CALIFORNIA COASTAL COMMISSION

COASTAL DEVELOPMENT PERMIT APPLICATION

Application number A-3-SLO-01-018, Gonyer SFD

Project description Construct a single-family residence with a 1,029 sq. ft. footprint and 1,744 sq. ft. of gross structural area.

LOWER FLOOR PLAN GSA

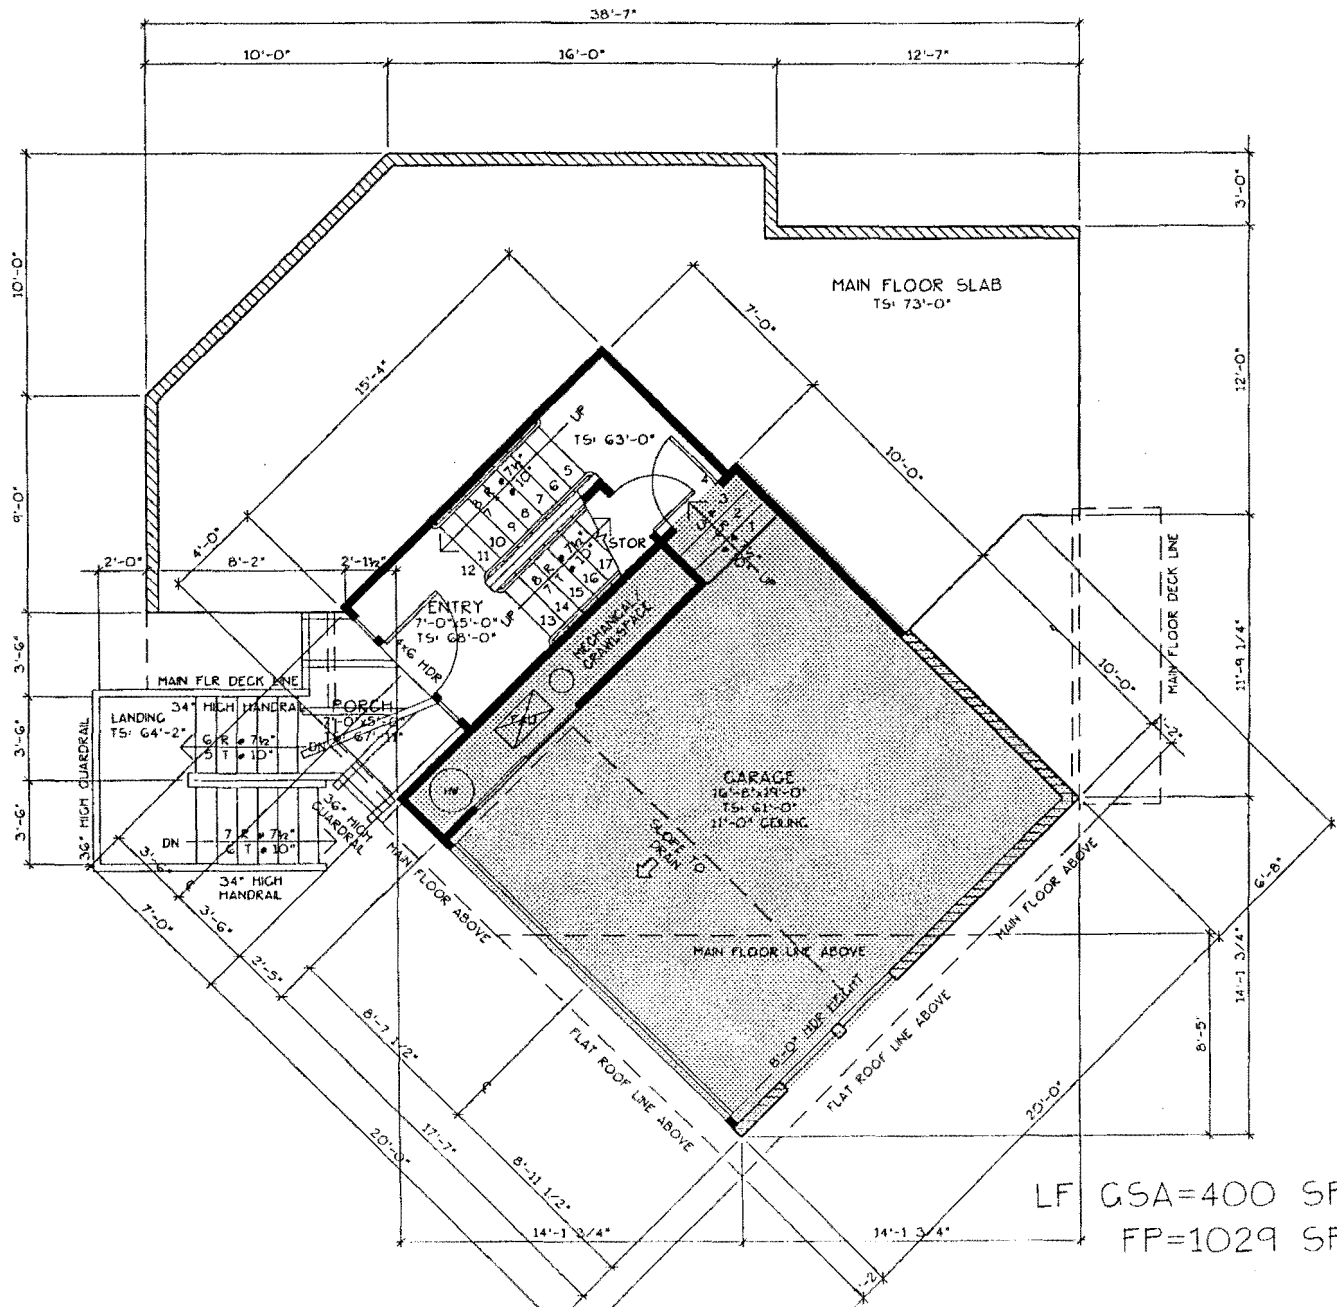
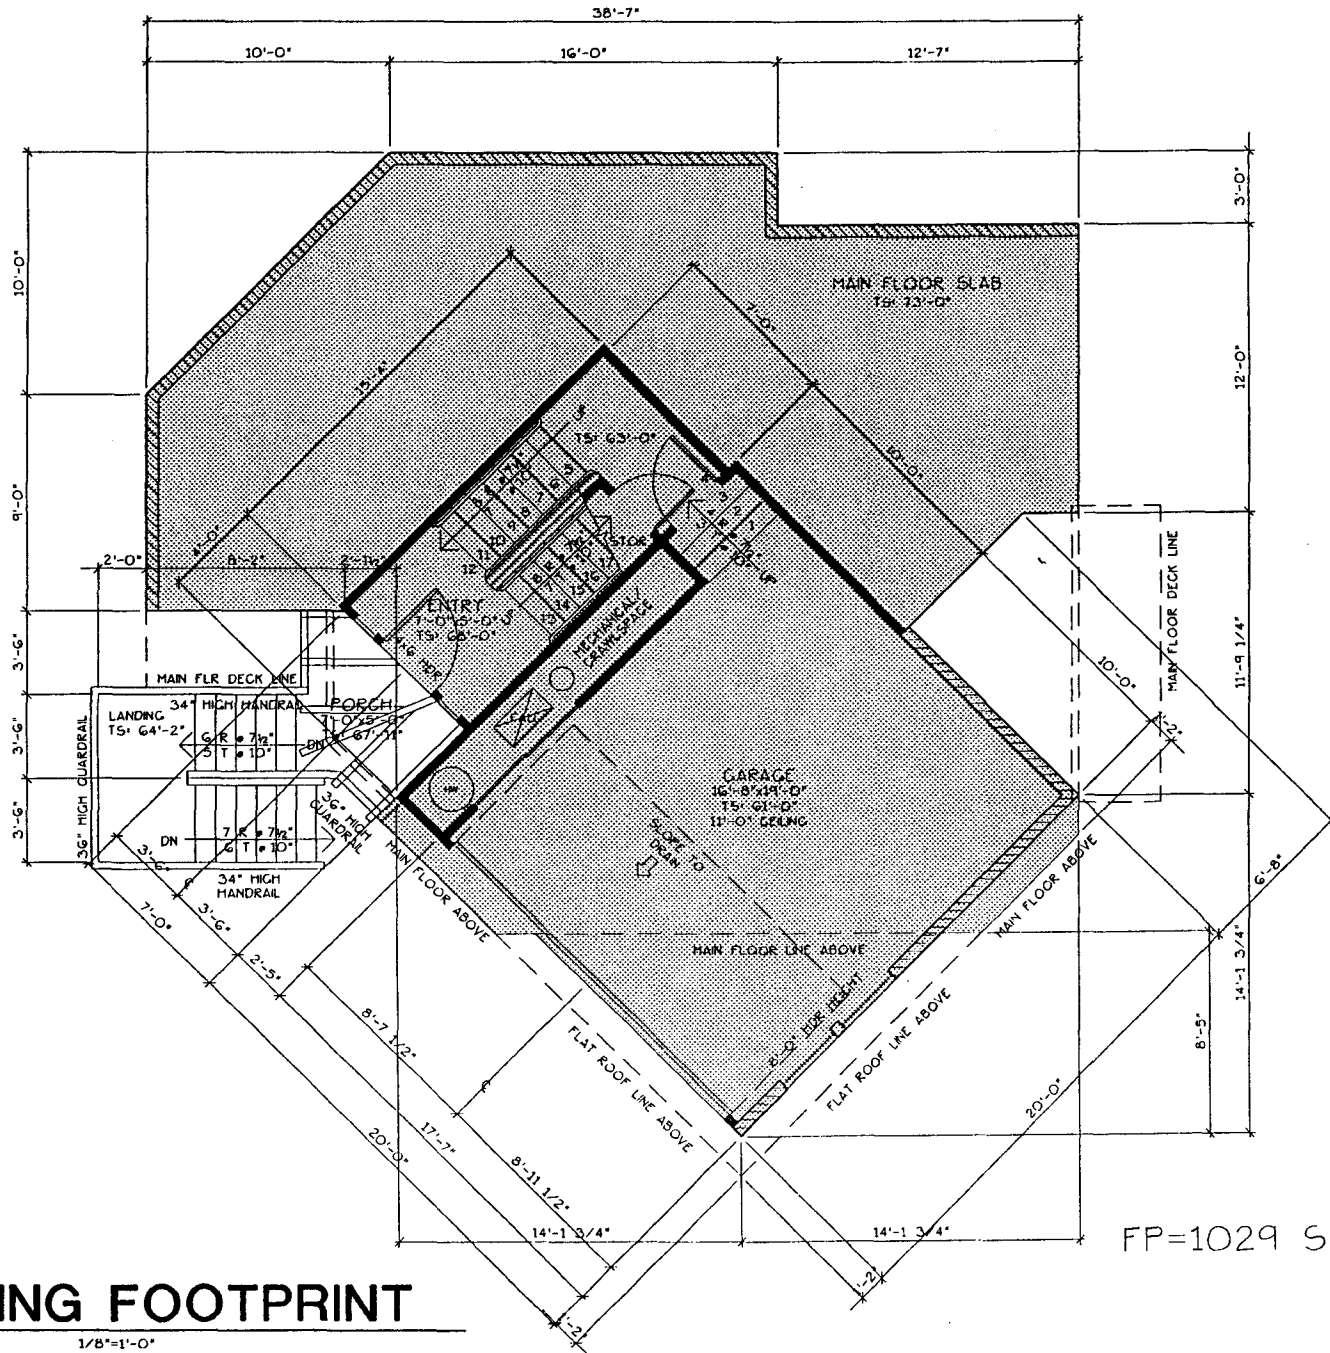
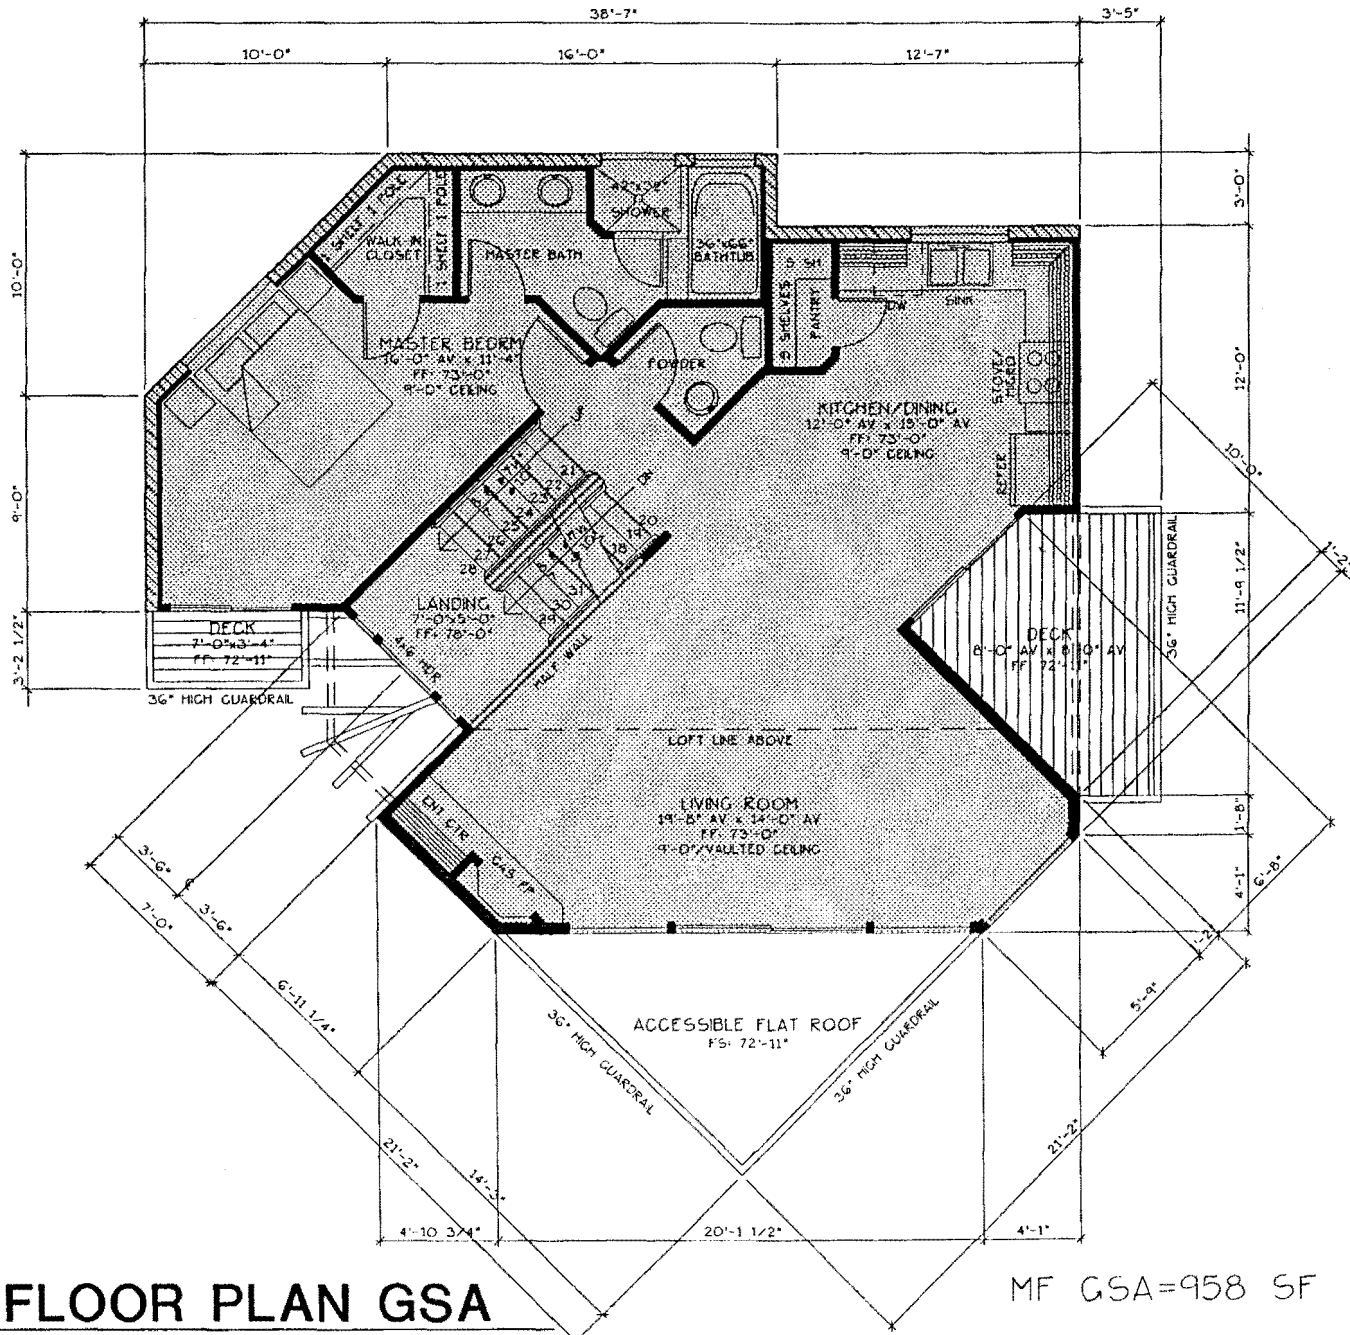
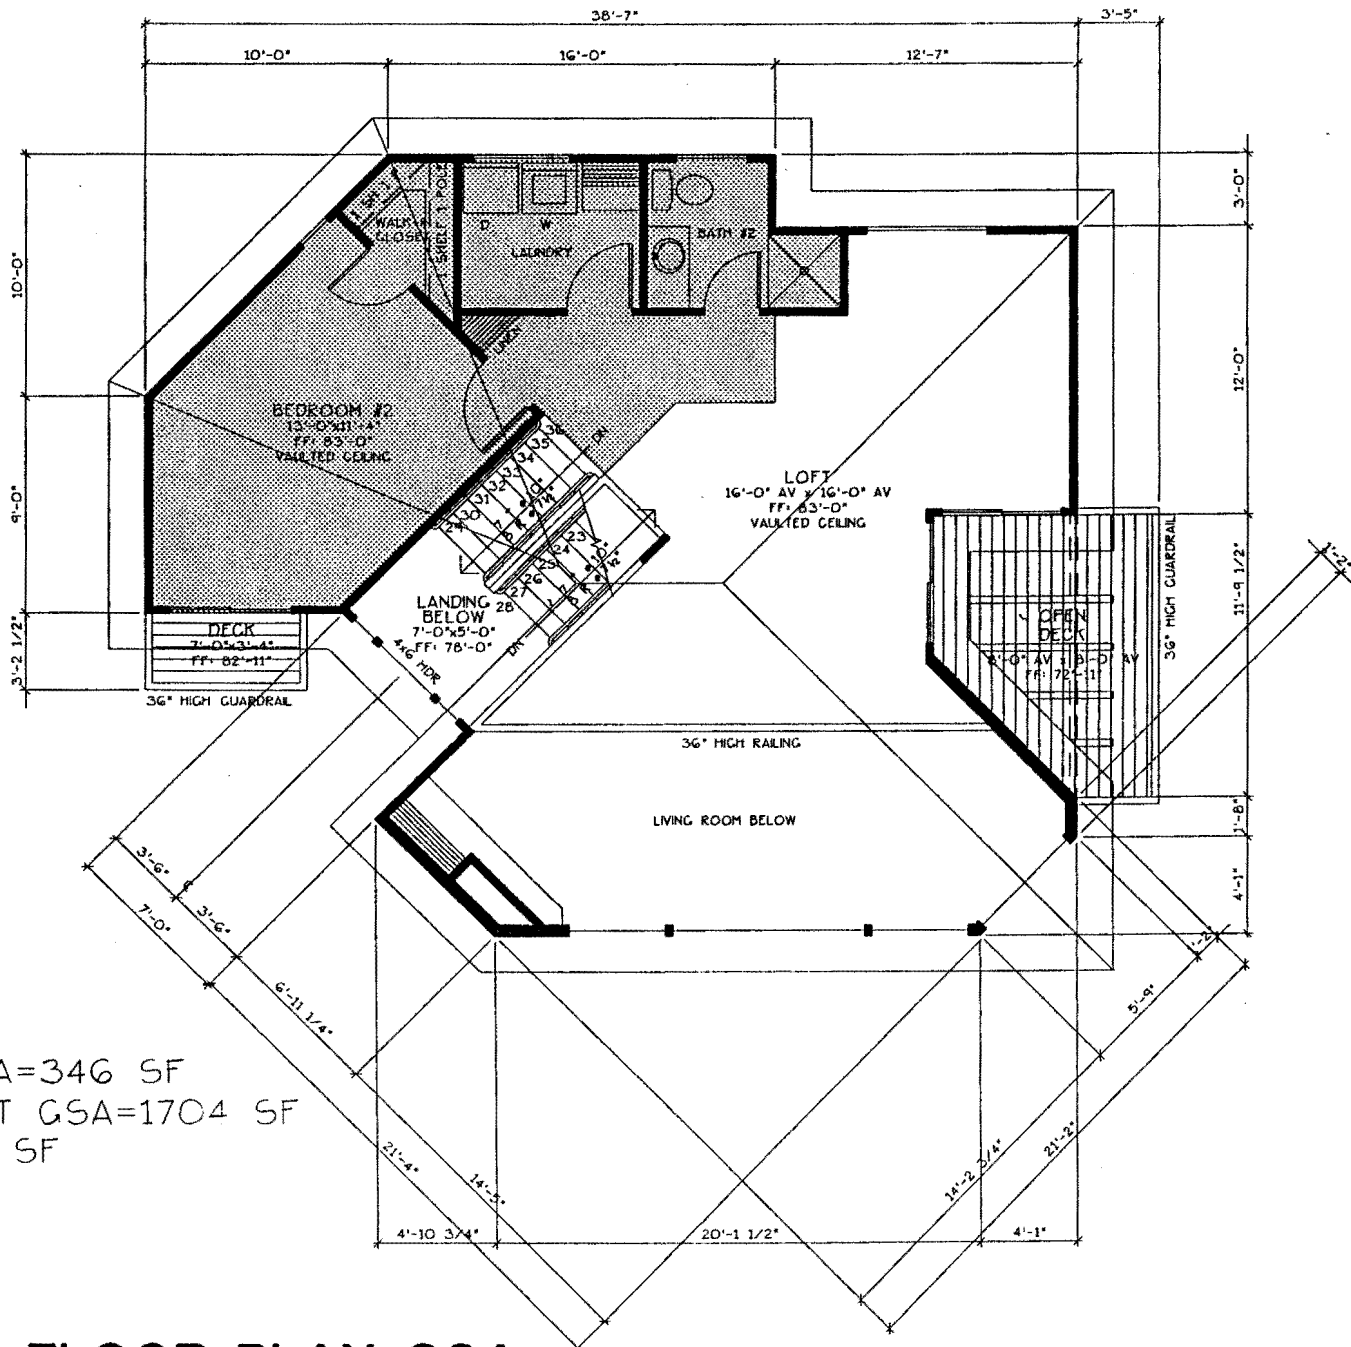
In addition, the footprint of the originally proposed residence has been calculated at approximately 1,160 square feet, which exceeds by the maximum footprint allowed under Table G by 129 square feet. The difference between this calculation and that submitted with the original plans is that the previously submitted calculation had not counted structural overhangs/covered deck areas as required by the LCP.

To resolve these issues, the applicant has submitted revised plans, attached to the staff report as Exhibit 2. To bring the project into conformance with the LCP size limitations discussed above, these revised plans:

With these changes, the project has a total footprint of 1,029 square feet and a total gross structural area of 1,704 square feet. Thus, the revised project conforms to the maximum 1,031 square foot footprint and 1,746 square feet of gross structural area established by the LCP.
